Interactive comment on “Measurements of Hydrodynamics, Sediment, Morphology and Benthos on Ameland Ebb-Tidal Delta and Lower Shoreface” by Bram C. van Prooijen et al.

Received and published: 7 September 2020

Fig. 1. interactive map with locations of the measurements.

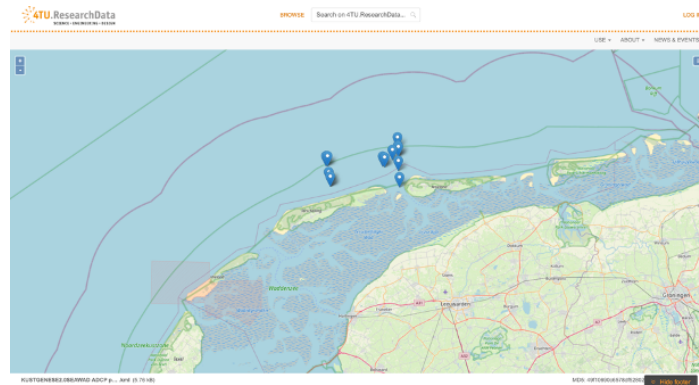
It would be helpful to add a table of dates and coverages for the platforms/instruments, unless this is somewhere in the repository/supplemental that I didn't see.

[We included a table with the frames for the different campaigns. See table 2 in the text. Furthermore, the site where the data is stored provides viewing options now as well. The position of the frames is directly visible on an interactive map, see for example Figure 1 or: \[https://data.4tu.nl/articles/dataset/KUSTGENESE2_0_SEAWAD_Frame-Mounted_Velocity_Profiler/12705962\]\(https://data.4tu.nl/articles/dataset/KUSTGENESE2_0_SEAWAD_Frame-Mounted_Velocity_Profiler/12705962\)](#)

Fig. 2. calibration of one of the compasses

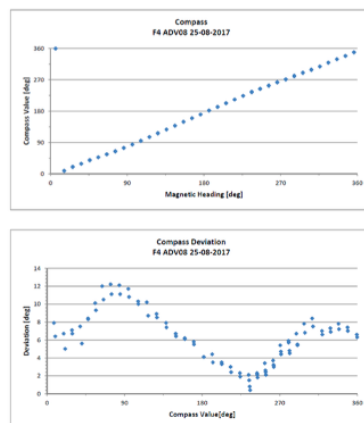
Within the text, it would be good to document the pre-deployment calibration steps for the various instruments. As it stands the calibration for only one instrument is described (LISST), and it is embedded in the post-processing section. I would at least add documentation on calibration of the optical sensors, compass calibrations for the velocity meters, and pressure-zeroing for the pressure sensors. It may seem trivial but it is important for inter-operability to know how instruments were prepared.

[We agree that this aspect was not sufficiently described. Compass calibration for the instruments on the frames was carried out prior to the campaign. An example result](#)

is shown below. We briefly explain the procedure in the text: *“The procedure for determining the offset of the compass was to rotate the mounting frame annotating every ten degrees the device heading angle (compass heading) and the true angle measured with high accuracy GPS (magnetic heading) not affected by the frame. This was repeated in reverse direction. An averaged compass deviation (from the two cycles) at a 10-degree interval was taken for the compass calibration.”*
